RE: APPLICATION FOR A VARIATION TO THE ABLE MARINE ENERGY PARK (AMEP) DEVELOPMENT CONSENT ORDER DEEMED MARINE LICENCE UNDER SECTION 72(3)(D) OF THE MARINE AND COASTAL ACCESS ACT

2.0 PROPOSED MATERIAL CHANGE 2

3.0 DEEMED MARINE LICENCE VARIATION

Figure 1: Consented Quay Alignment and Proposed Changes

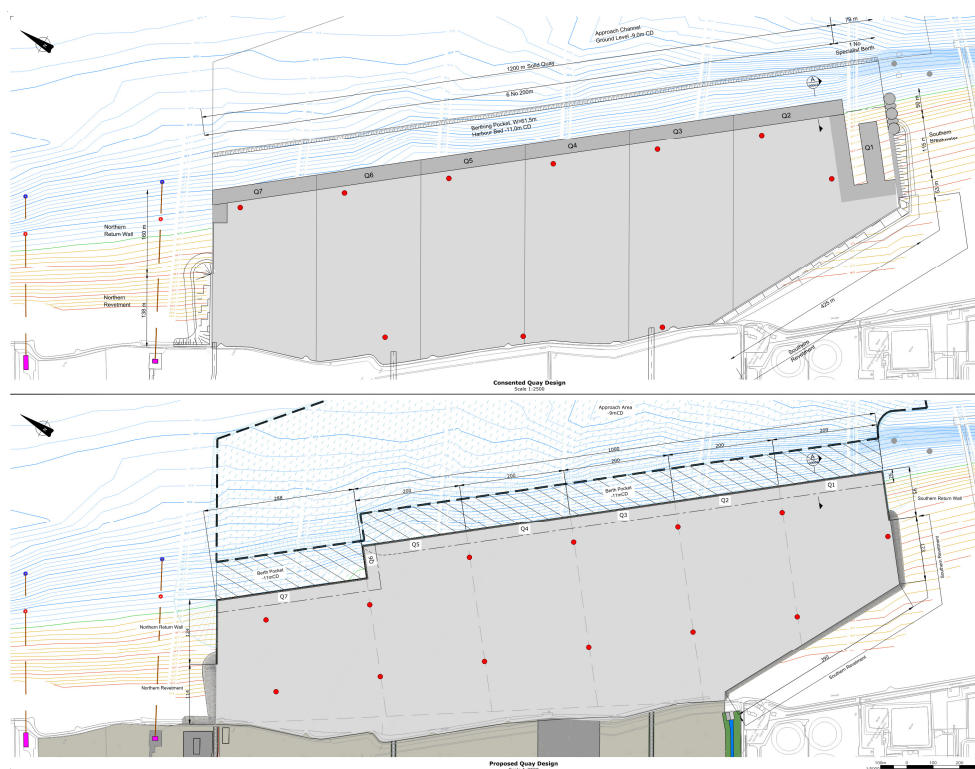
- The specialist berth at the southern end of the quay is to be reclaimed as the vessel that was to use the facility (refer to Figure 5.18 of the original ES) has not been constructed and is not likely to be built;

- At the northern end of the quay, the quay line is to be set back 61m over a length of 288 m to create a barge berth and allow the potential for end load in of cargo from Ro-Ro vessels;

The net effect of changes (a) and (b) above is that marginally less land would be reclaimed from the estuary, refer to Figure 1. Nevertheless, no changes are proposed to the compensation proposals taken into account in the Secretary of State’s Habitats Regulations Assessment for the consented development. The change in habitat loss is summarised in Table 2 below, and the amendment results in a net reduction in the footprint of the quay from 45ha to 43.6ha. The changes are further detailed on drawings AME-036-00001 - 00002 at Appendix UES4-1.

Figure 2: Revised Indicative Cross Dam Positions in light red Shading (original dams in orange shading, Anglian Water outfalls as red lines)

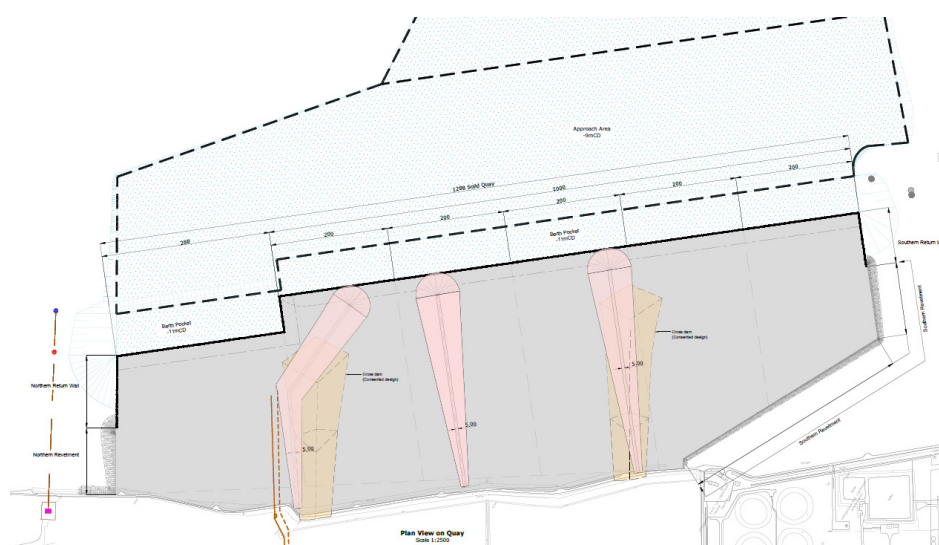
Certain details of the reclamation are prescribed in Schedule 8, paragraph 4 of the DCO (Technical Appendix UES1-1). Specifically, paragraph 4(f) states that the estuary, 'may be reclaimed using marine dredged sands and gravels by constructing two granular dams that extend from the existing flood defence wall to the area reclaimed..., so that the dams divide the remaining reclaim area into three approximately equal cells' (underline added).

Anglian Water has two pipelines which discharge within the footprint of the reclamation area between the existing flood defence wall and the new Quay wall refer to Figure 2. In order to facilitate the diversion of these outfalls, and to facilitate sectional completion of the Quay, it is necessary to introduce a third cross dam within the reclamation area. An amendment is sought to permit this change.
